MSOS104A-03C

# Modification Recommended Service Note

## MSOS104A – MSO Infiniium S Series 1GHz 4 channel

The Problem – Under certain circumstances a PLL2 error may occur on the S-series products.

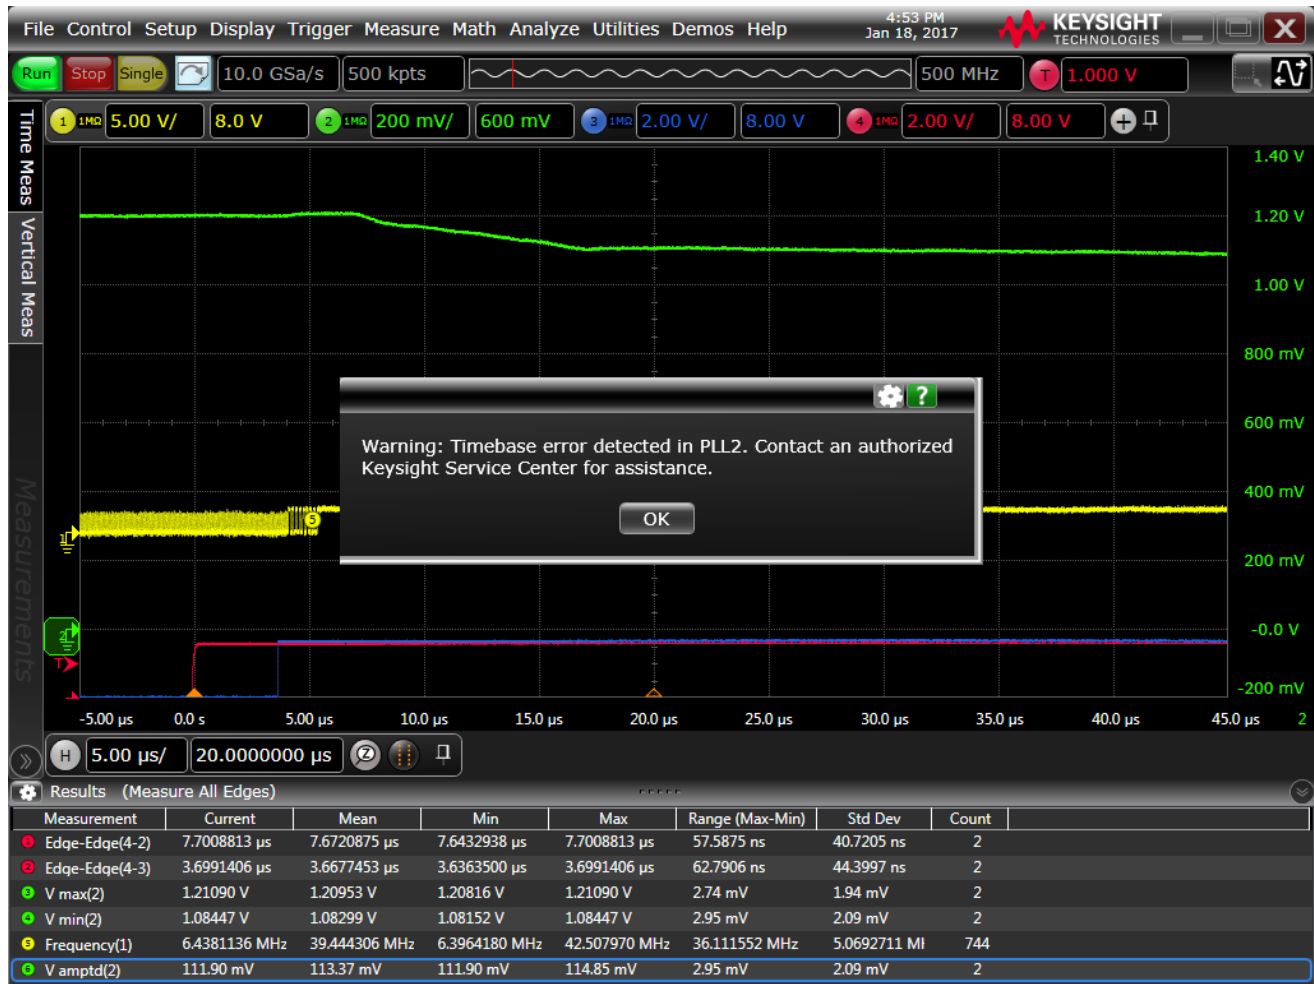
On older acquisition boards a PLL2 error message sometimes occurs. The error message appears on the screen as below:

There are new acquisition boards that fix this issue for the S-series scopes.

1. If the customer needs to have software revision < 6.10.01001, then replace the acquisition board with the 54911-69532 board.
2. If the customer can have software revision >= 6.10.01001, then it can be replaced by any of these three boards: 54911-69521, 54911-69531, or 54911-69532.
3. Save the Serial Numbers of the replaced and the new Acquisition Boards in Siebel. Please, follow this procedure:
  - a. For each Service Order in Siebel, there is a tab labeled Activities:
